Shire Car Park  
Layout Change

Drawing No.  
**CP-SHIRE-SA-V1**

### Stewart St Parking Bays

Drawing No.  
**RD-STEWART-SA-V1**

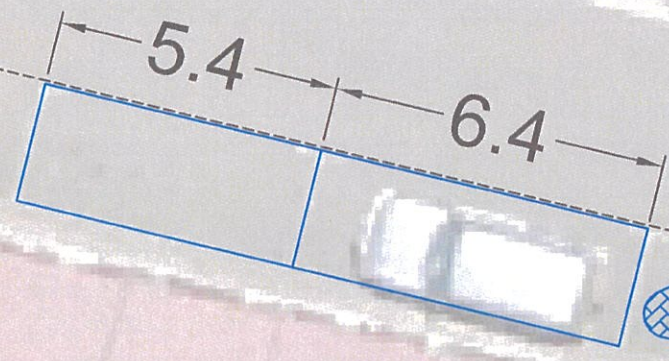
Remove parking bay  
(extend existing paved area)

Install R1-2

Install raised island  
(300mm from traffic lane to avoid services &  
300mm from footpath for drainage channel)

Install raised island  
(300mm from traffic lane to align with  
adjacent island)

Retain existing  
Give Way sign

Remove old  
holding line

Remove  
redundant islands  
impeding footpath

Extend concrete kerbing to join existing kerbing to the south.

Install 5 x 7m parking bays.

Extend kerbing
